ROBERT MOORE PARK SUBDIVISION, **RESUBDIVISION OF LOT 1**

APPLICATION NUMBER 12 DATE August 6, 2015
APPLICANT Robert Moore Park Subdivision, Resubdivision of Lot 1
REQUEST Subdivision

DETAIL SITE PLAN

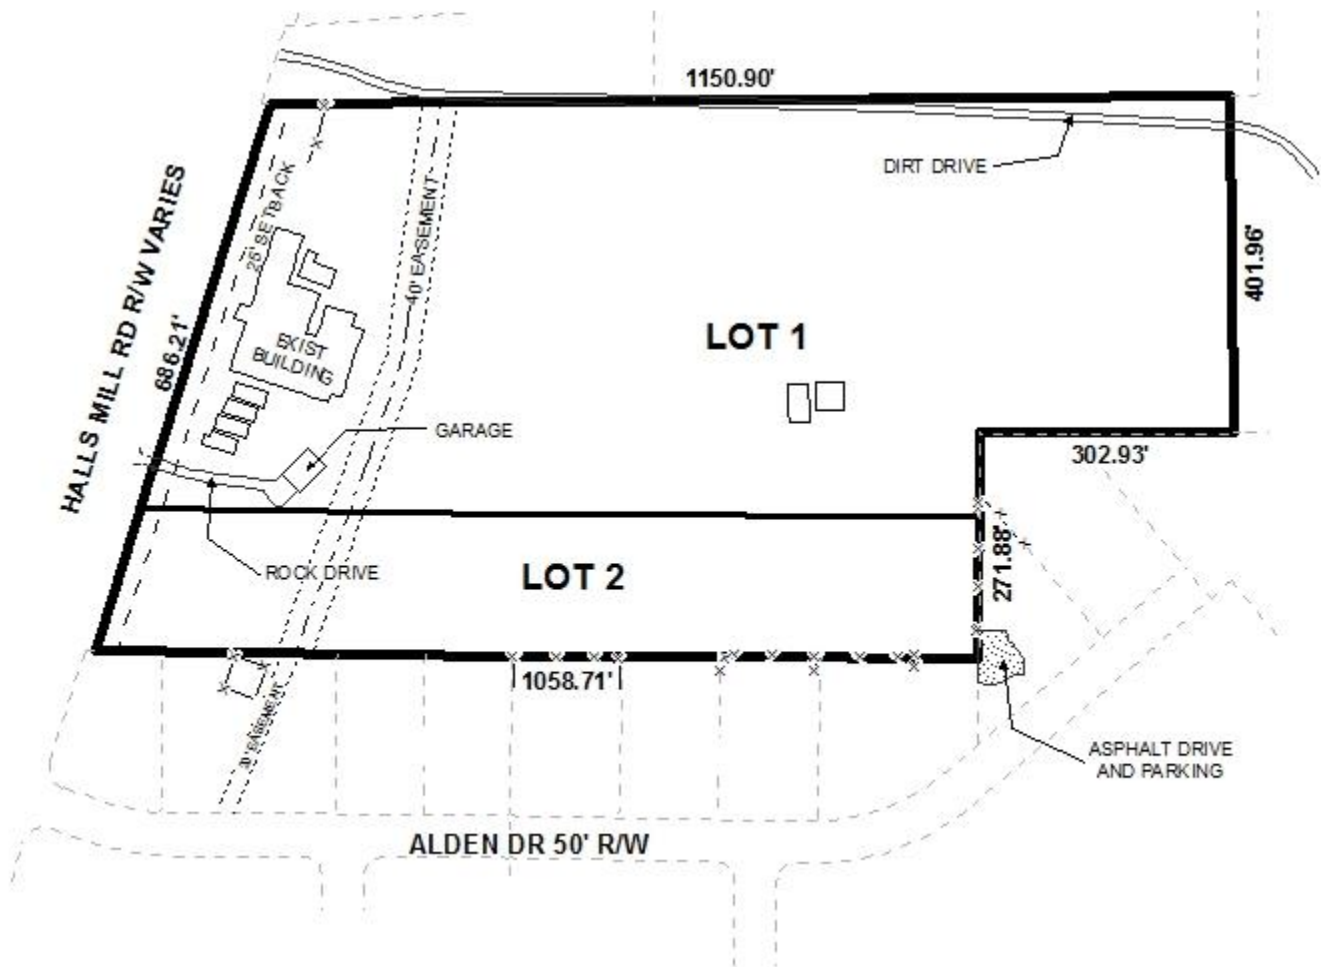
The site fronts onto Halls Mill Road, a collector street, with a required 70' right-of-way and a current 35' from the centerline of the right-of-way along the site. Therefore, no dedication would be required. Proposed Lot 1 is already developed with multiple curb cuts. As a means of access management, a note should be required on the Final Plat stating that Lot 1 is limited to the existing curb cuts to Halls Mill Road. Proposed Lot 2 is undeveloped. As per Traffic Engineering, a note should be required on the Final Plat stating that Lot 2 is limited to two curb cuts to Halls Mill Road, with the size, location and design to be approved by Traffic Engineering and conform to AASHTO standards.

Each lot meets the minimum area and width requirements of the Subdivision Regulations. Lot 2 would exceed the depth-to-width ratio limit of Section V.D.3. of the Subdivision Regulations; however, as narrow lots are common within the area, a waiver of this Section would seem in order. The plat should be revised to label each lot with its size in both square feet and acres, or a table should be furnished on the Final Plat providing the same information. As on the preliminary plat, the 25' minimum building setback line along Halls Mill Road should be retained on the Final Plat.

A 40' wide drainage easement traverses both proposed lots. Therefore, a note should be required on the Final Plat stating that no structures may be constructed within the drainage easement.

- 1) placement of a note on the Final Plat stating that a Planned Unit Development (PUD) application will be necessary at the time of proposed development for either lot to amend the previously approved PUD (ZON2008-02059) for the site;
- 2) placement of a note on the Final Plat stating that Lot 1 is limited to the existing curb cuts to Halls Mill Road;
- 3) placement of a note on the Final Plat stating that Lot 2 is limited to two curb cuts, with the size, location and design to be approved by Traffic Engineering and conform to AASHTO standards;

- 4) revision of the plat to label each lot with its size in both square feet and acres, or the furnishing of a table on the Final Plat providing the same information;

- 5) retention of the 25' minimum building setback line along Halls Mill Road on the Final Plat;
- 6) placement of a note on the Final Plat stating that no structures may be constructed within the 40' wide drainage easement across the site;
